Application for Amendment of Plan Under Section 12A of the Town Planning Ordinance (Cap. 131) to Rezone the Application Site from “Green Belt” and Area shown as ‘Road’ to “Residential (Group C)5” for Proposed Residential Development at Various Lots in D.D. 210 and Adjoining Government Land, Pak Wai, Sai Kung (Planning Application No. Y/SK-HC/8)

Submission of Further Information – Responses to Departmental Comments

Responses-to-Comments Table

FIGURE 4

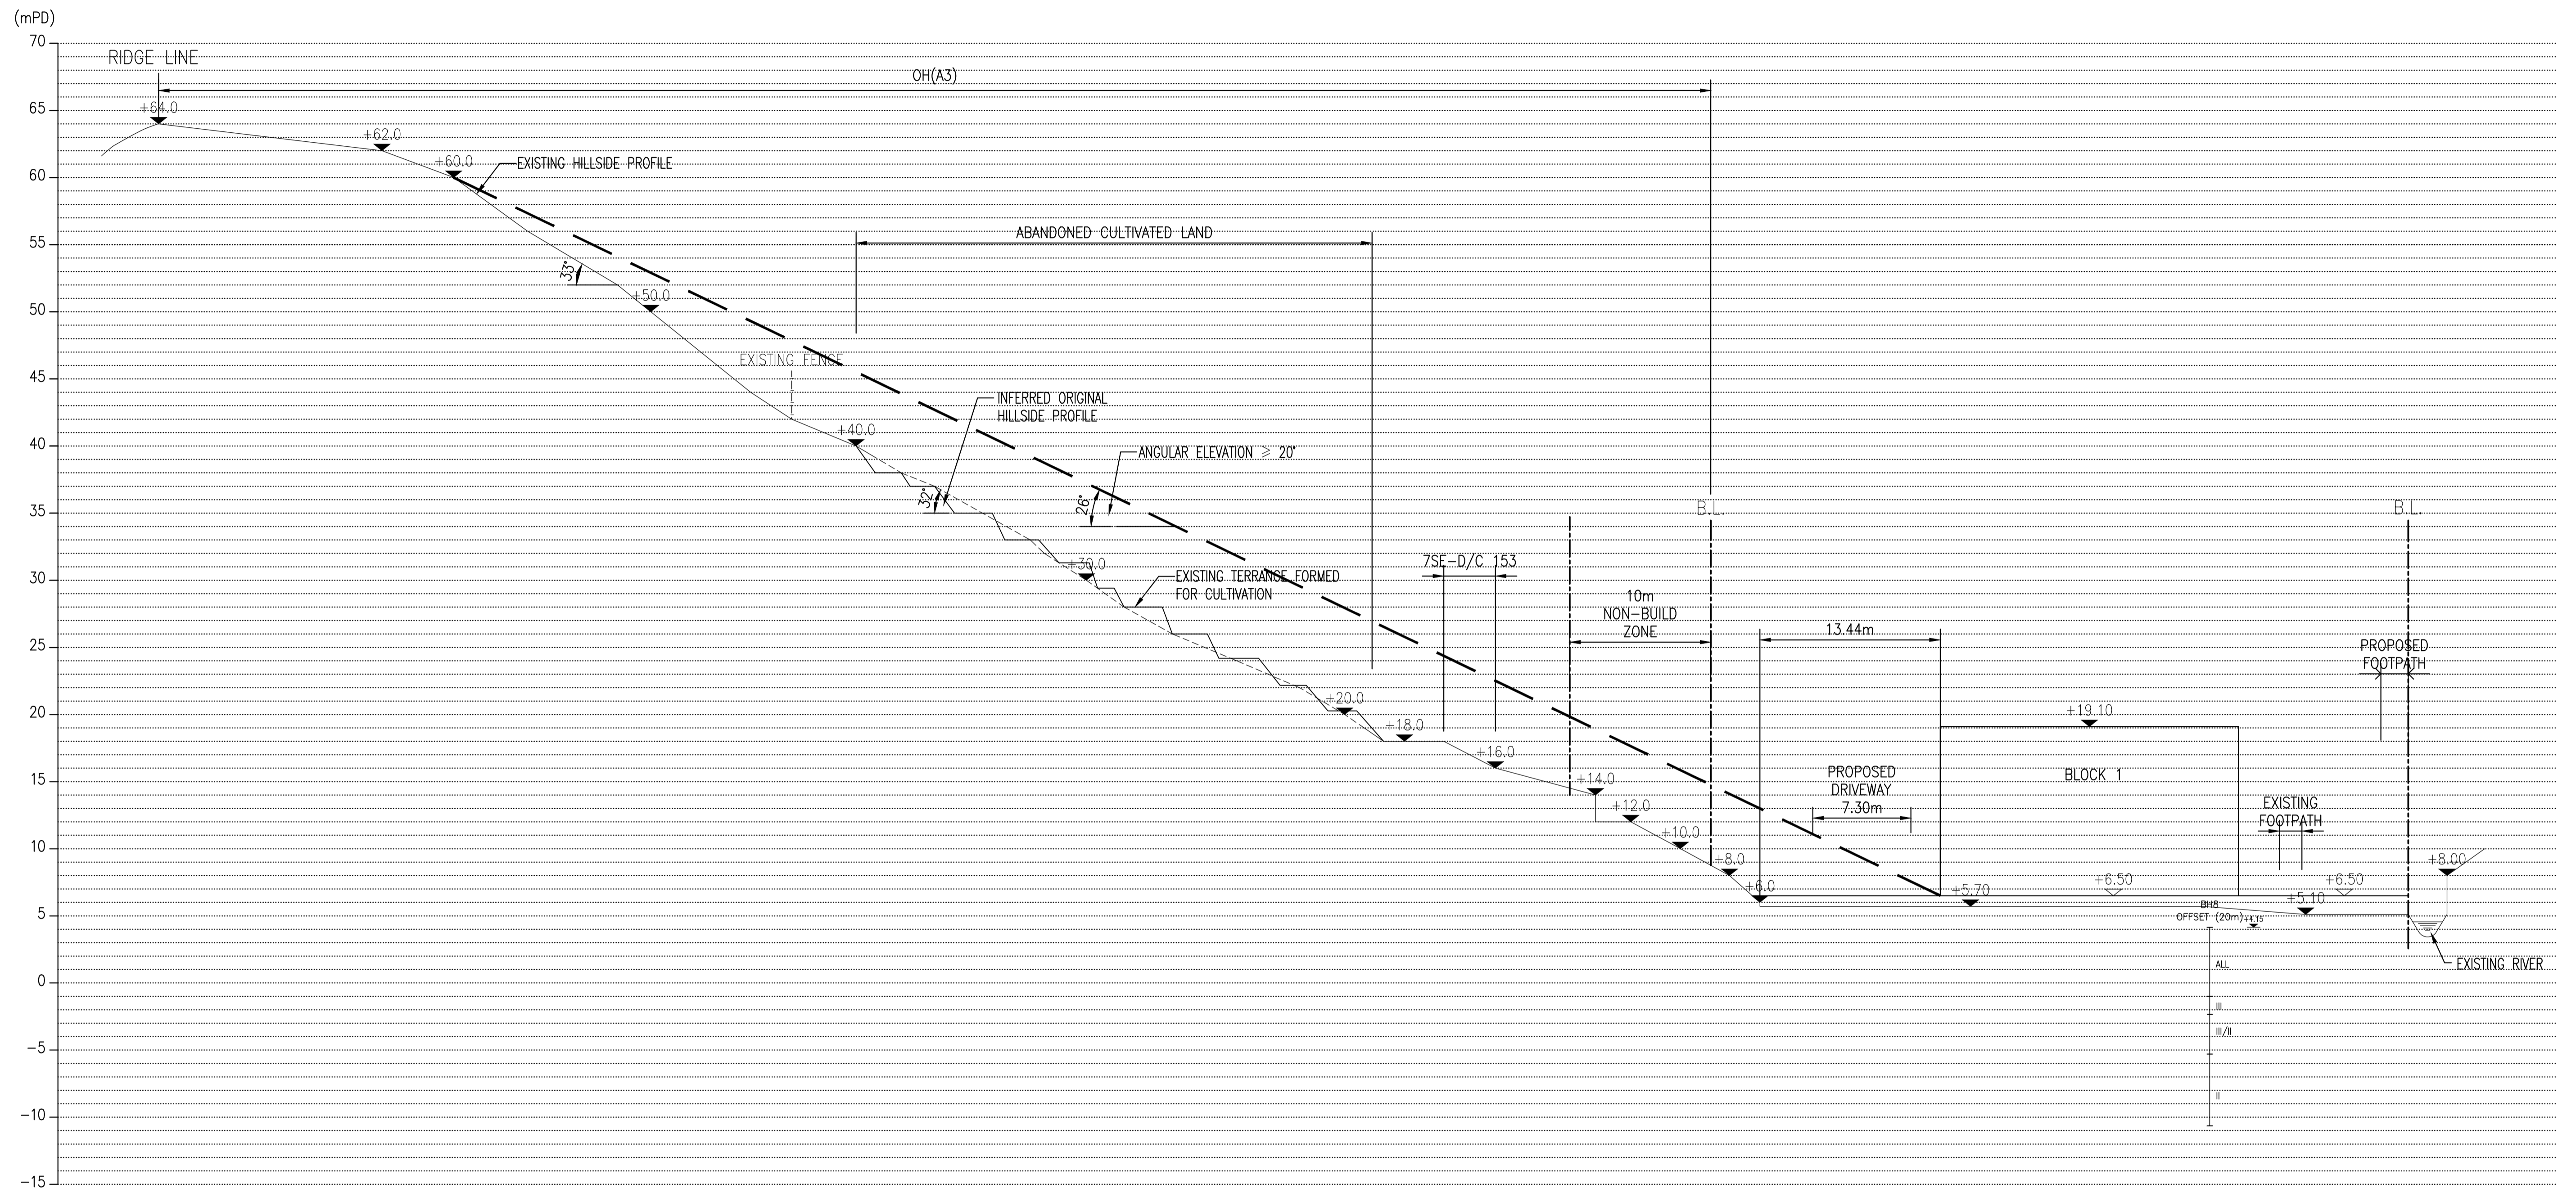
No.	Comments	Responses
	<p>a. Further amendments are required for catchment boundaries clouded in the attached plan. For example, the hillside above the crest of catchment CD(1), OH(A2) and OH(B) shall be included as part of the catchments. Minor portions of hillside to the southeast of catchment TD(1) and OH(A1) shall be included as part of the catchments. The southwestern portion of catchment OH(A1) does not overlook the site. Please review and amend the catchment boundaries based on the topography.</p> <p>b. The toe of the catchments shall extend to adjoin the site boundary.</p> <p>c. Figures 5 - 10: The AOR shall be measured along the steepest credible flow path. For example, in Section B-B (Figure 6), the crest to measure the AOR from the site shall be the point of elevation at +50mPD on the ground profile instead of +54mPD, which will result a steeper AOR at about 28°. Please review the other sections accordingly.</p> <p>2. It is noted that the AOR measured in the screening provided in the GPRR is based on measurement from the site boundary. Given the layout of the proposed development is available, the applicant may conduct the screening based on the facilities involved (i.e. residential buildings, club house, internal roads, swimming pool, footpath, etc.). If this approach is adopted, please classify each individual facility according to Table 2.2 of GEO Report No. 138, and reassess the AOR accordingly. This approach may provide a more refined delineation of the hillside requiring an NTHS. However, please note that the screening and extent of NTHS will need to be reviewed and updated if there are changes to the development layout.</p> <p style="text-align: center;"> Attached Plan.pdf</p>	<p>Noted. The catchment boundaries for OH(A1) have been revised and separated to OH(A1), OH(A2) and OH(A3), OH(A2) is renamed to OH(A4) and boundaries are extended.</p> <p>The catchment boundary of OH(B) has been renamed to OH(B1) and the boundary has been extended.</p> <p>The catchment boundary of TD(1) has been renamed to OH(B2) and the boundary has been extended.</p> <p>An addition catchment CD(2) has been added to cover the channelized catchment at the north-west of the lot.</p> <p>Please refer to Figure 4 of the Revised GPRR for the revised catchment.</p> <p>Noted. The catchments have been extended to adjoin the site boundary in the Revised GPRR.</p> <p>Noted. The measurement of the AOR has been revised. All sections have been revised accordingly under the Revised GPRR.</p> <p>Noted. The AOR is revised to measure from the nearest facilities. All sections are revised accordingly under the Revised GPRR.</p> <p>The screening and extent of NTHS will be reviewed and updated when the development layout is changed.</p>
